RE: OSC 16-01

Beverly L. McAfee has applied for an Open Space Community Overlay (R-20 to R-20 OSC), filed July 7, 2016 for property located at 693 Tarpley Road. The development proposal is located in LL 279 of the 20th District within Commission District 1.

The case is known as OSC 16-01 and has been reviewed by staff. A zoning analysis report, which includes staff comments and recommendations are attached, in addition a site narrative and straight R-20 plan has been provided by the applicant and is attached as well. There is a 30 day posting period according to the OSC ordinance and OSC 16-01 will be heard by both the Planning Commission and Board of Commissioners as an Other Business item during the September rezoning cycle.

Westover Pointe
Beverly McAlfee
Formerly subdivided as Lot 11 in Westover Farms S/T
as Recorded in Plat Book 163 Page 13
Land Lot 279 20th District 2nd Section
Cobb County Georgia
Field Date: 02-19-96 Plot Date: 07-20-06
Scale: 1"=30'

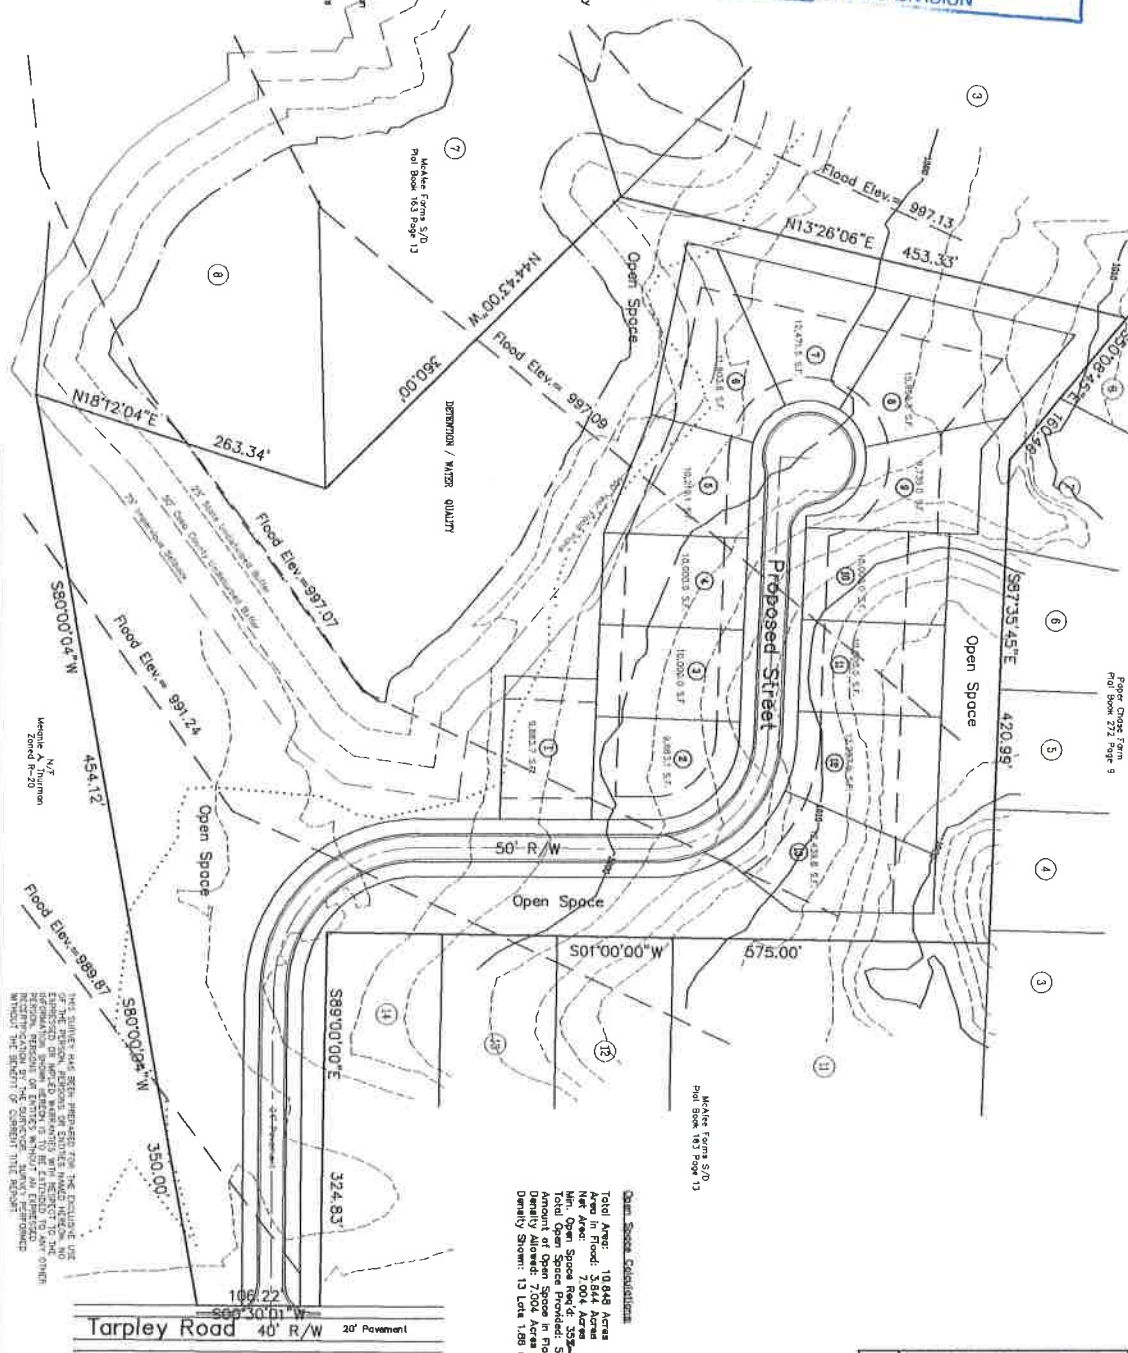
Development calculations as noted on site plan received on 07/07/16 meets the technical requirements of the OSC ordinance and exceeds the required percentage of open space that allows a density bonus up to 1.92 units per acre for an R-20 OSC. To further enhance this proposal and meet other aspects of the OSC ordinance, the following comments and recommendations should be met.

1. Lots 1, 5, & 6 encroach into 100 year flood plain. The floodplain is considered a primary conservation area and should be included within required open space.

2. Lots 5 & 6 encroach into the state and Cobb undisturbed stream buffer. Stream buffers are considered a primary conservation area and should be included within the required open space.

3. Overall residential development shall be compatible with neighboring residential uses. Adjacent residential uses are ~20,000 SF to the north and east and ~3 acres to the west. Consider larger lot sizes to allow proposed development to be more compatible to the character of the area.

4. If walking or bike trails are proposed throughout open space please add them to site plan and note that they will be constructed of porous materials.

3. The proposed site plan must be revised so that all the lots are located outside the 100-year floodplain of Mud Creek.
4. This site receives runoff from the Paper Chase Farm Subdivision to the north. Adequate conveyance of the existing offsite runoff must be accommodated through the site. A 20-foot drainage easement for this conveyance will be required.
